Heritage Advisory Committee
May 22, 2013

SUBJECT: **Case H00373: Substantial Alteration to 4 York Redoubt Crescent, Fergusons Cove (Stella Maris Church), a registered municipal heritage property**

ATTACHMENT B: FRONT ELEVATION

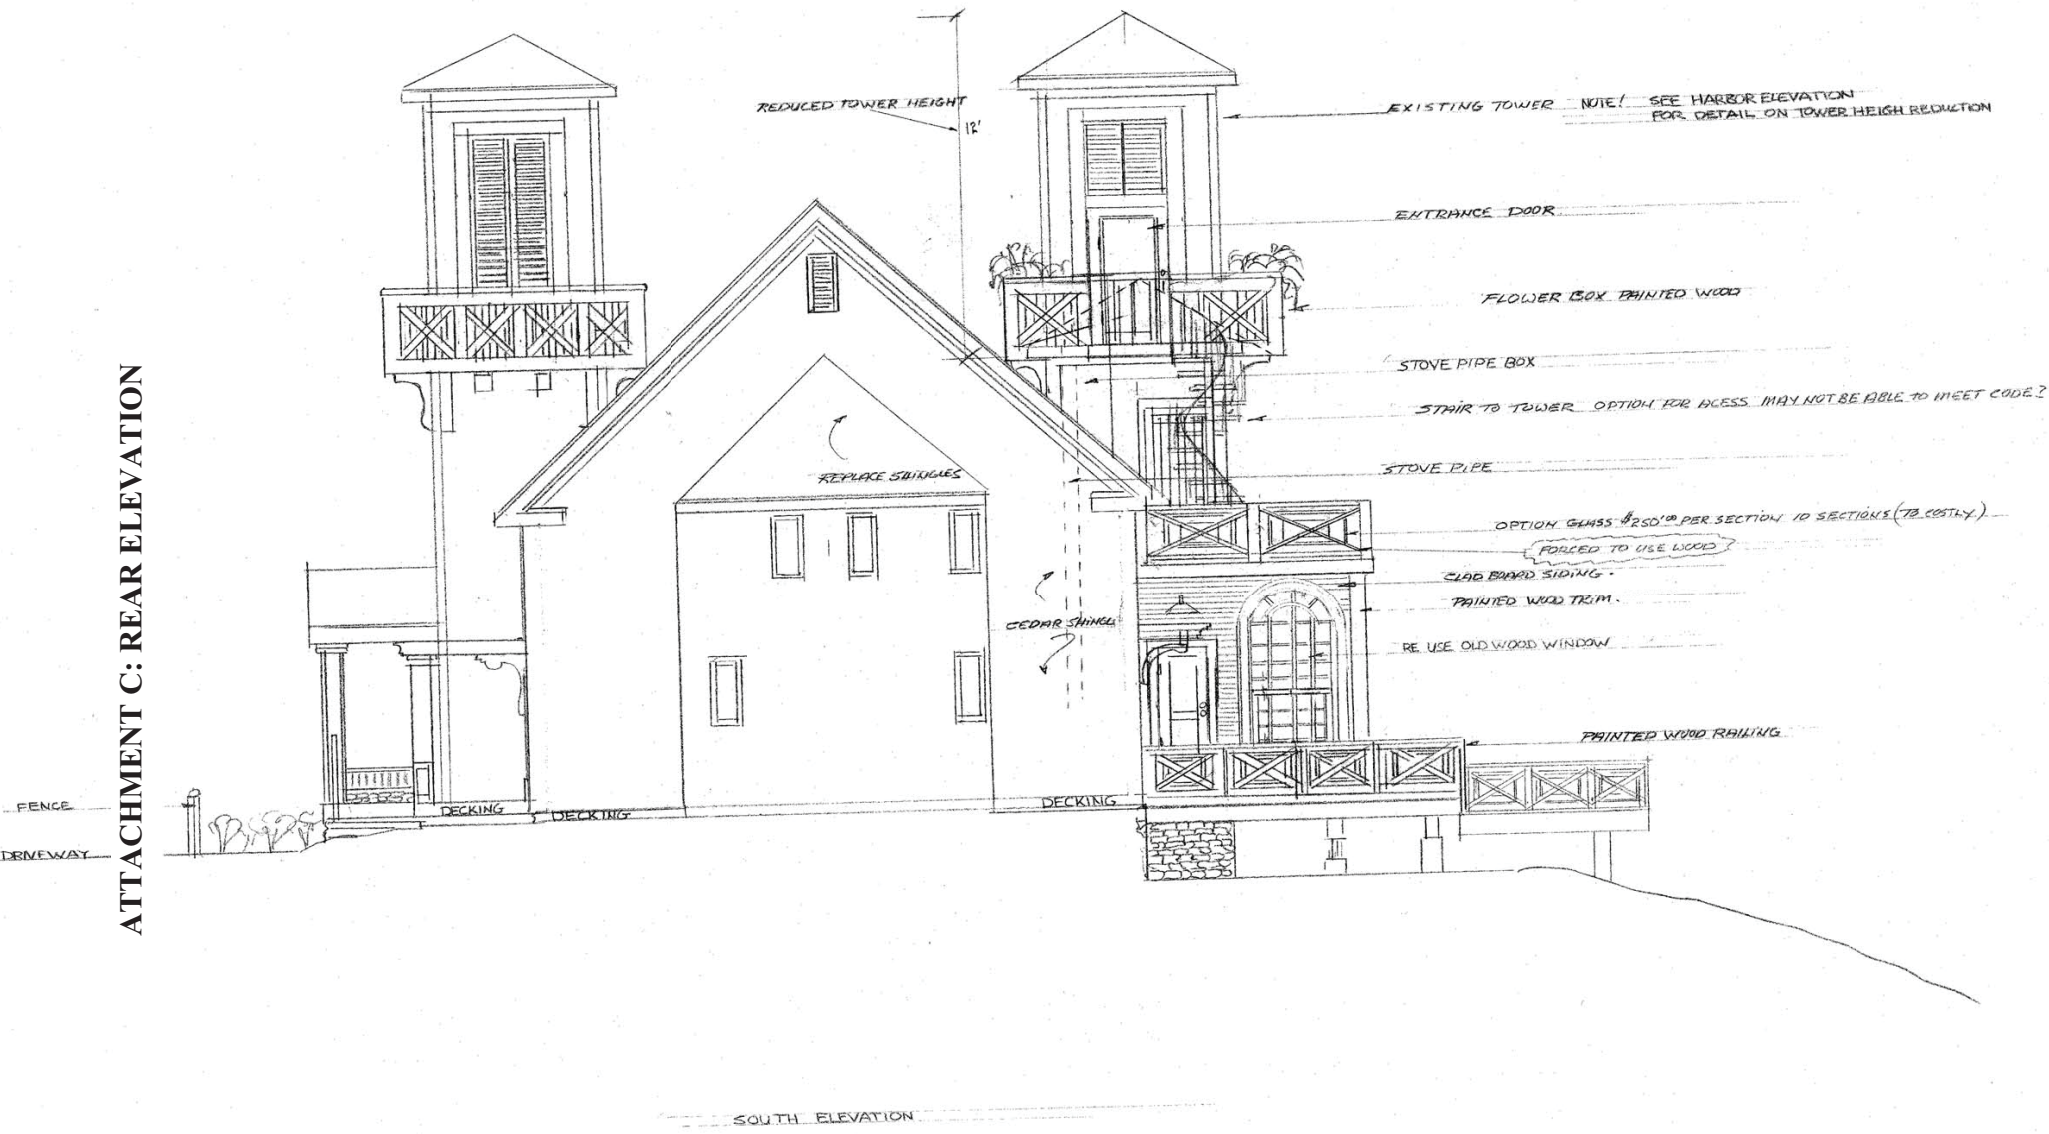
insurance liability. To provide this option, this proposal must be understood to include the preservation of one tower in its entirety and only half of the harbour-side tower. On the front façade, all framed openings will be preserved. Three of the Classic Revival style wooden windows will be replaced with vinyl in like appearance. The opening holding the copper alcove will be converted to a patio doorway while the top portion of the copper alcove will be cut and retained in place as a heritage feature. A new second storey will be contained entirely within the existing building envelope by installing an internal platform. As a result, three of the tall window openings along one side will be divided into two separate windows while emulating their original proportions within their original frames.

ATTACHMENT C: REAR ELEVATION

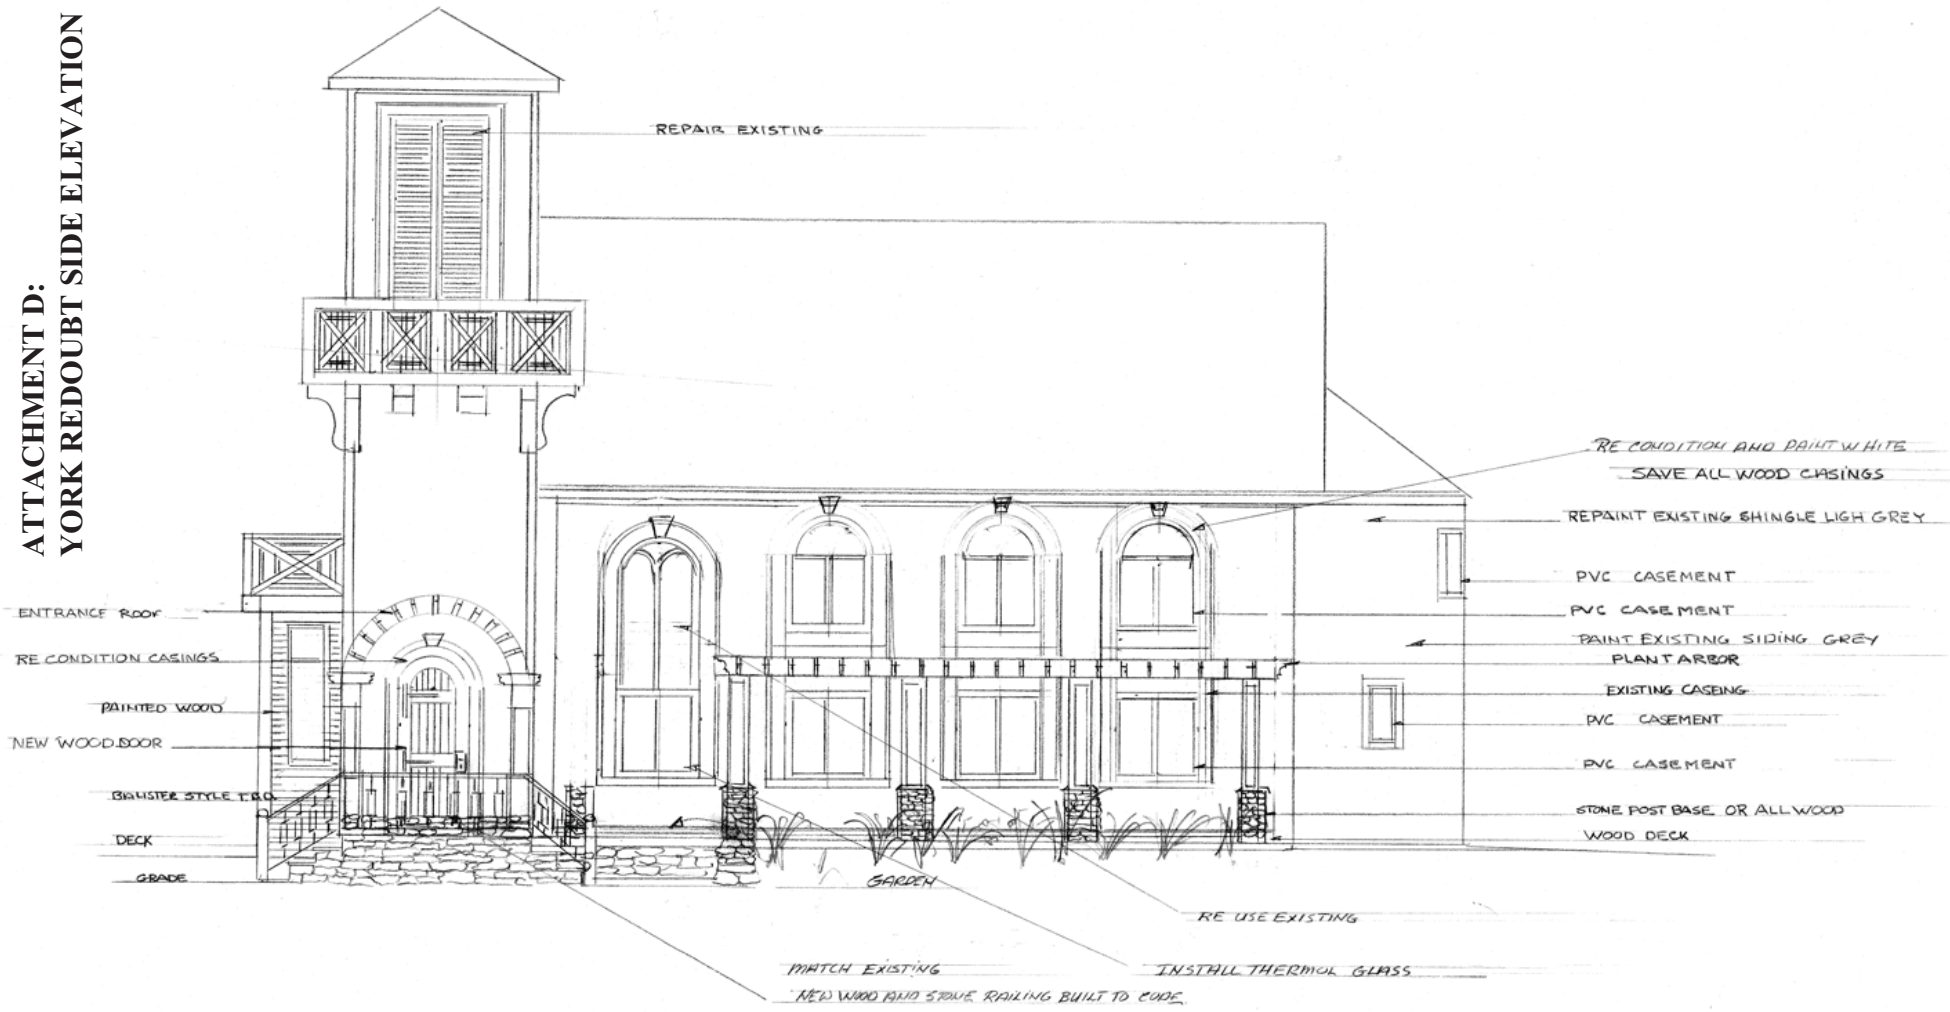
- **New Additions: Differentiated and Compatible with Massing, Size, and Scale:** This proposal consists of two new additions: a harbour-side sunroom and a front veranda. Both the sunroom and veranda additions are compatible with the heritage building in terms of their massing, size, and scale. They will be clearly distinguished as modern structures clad with a cement board material in a different colour from the heritage building. The harbour-side sunroom addition and the adjacent sliding glass door will replace the historic tall windows on this side of the building.

**ATTACHMENT D:
YORK REDOUBT SIDE ELEVATION**

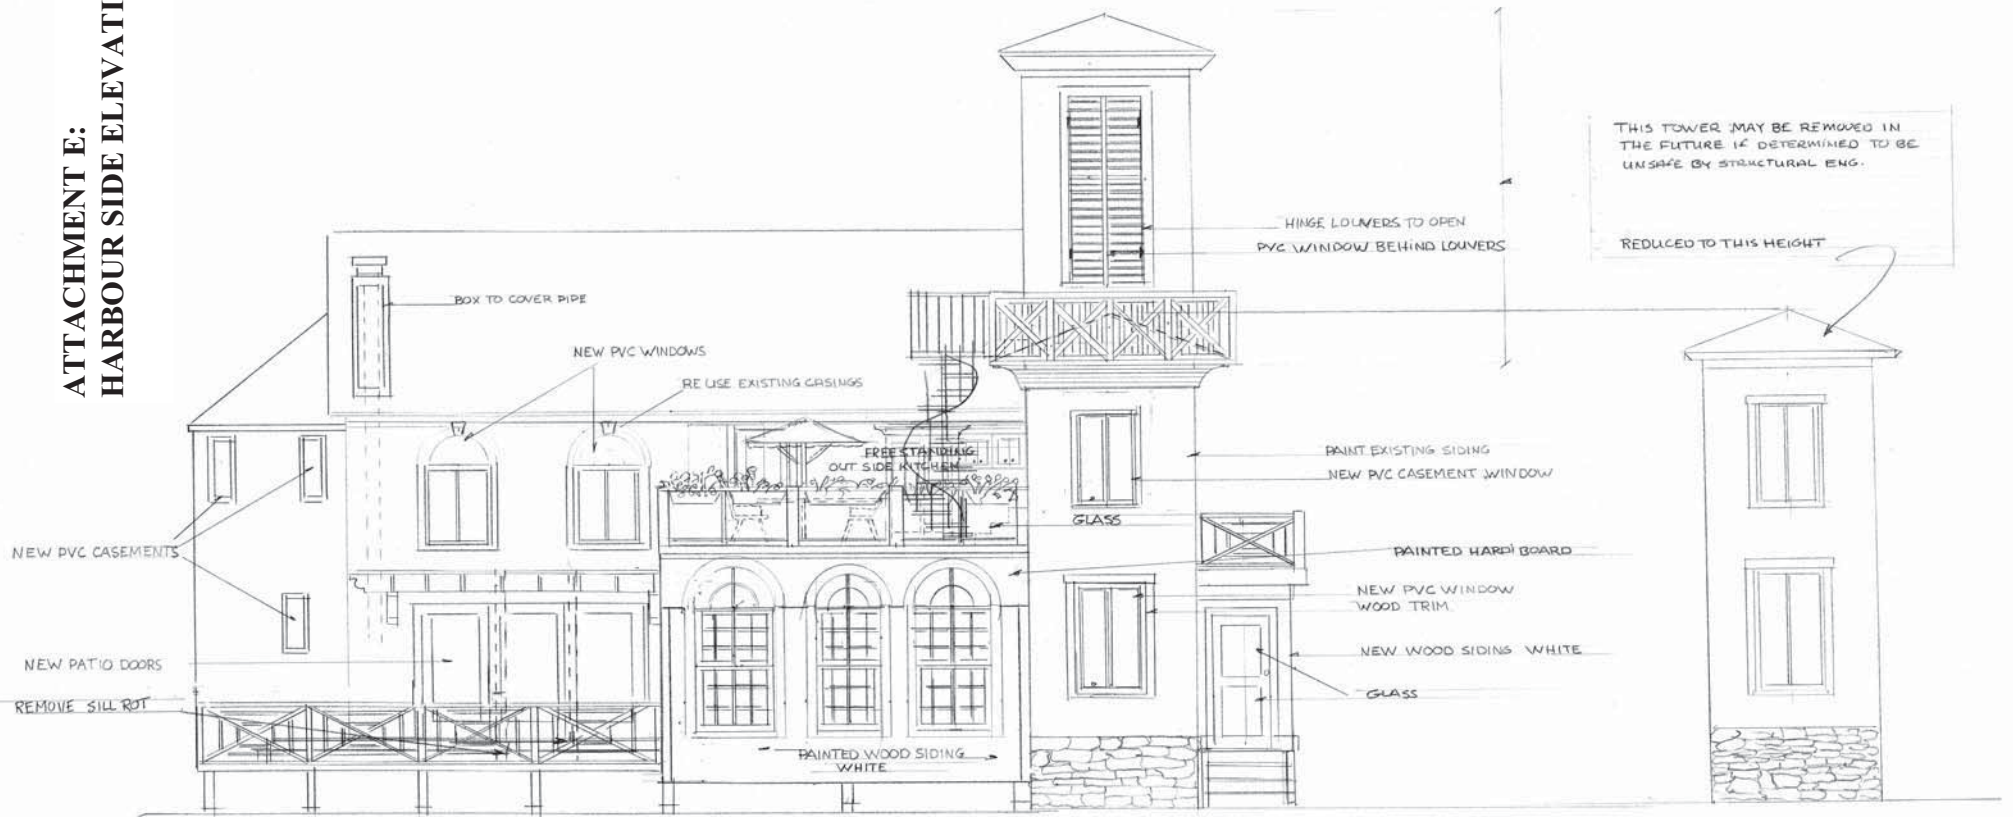
- **New Additions: Essential Form and Integrity Remains Unimpaired:** The heavy timber construction will be largely preserved within the existing building frame. New openings into the sunroom and veranda additions will be between existing timber posts. The only alteration to the heavy timber construction is on the harbour side where two timber posts will be cut and reframed for the sliding glass door. An HRM Building Official has confirmed that the new second storey platform will provide a structural benefit in stabilizing the timber frame construction. All three additions can be removed in the future and the essential form and integrity of the heritage building and its environment would be unimpaired. Furthermore, all original windows will be salvaged by reincorporating them in the sunroom addition, interior walls, or by storing them within the building.
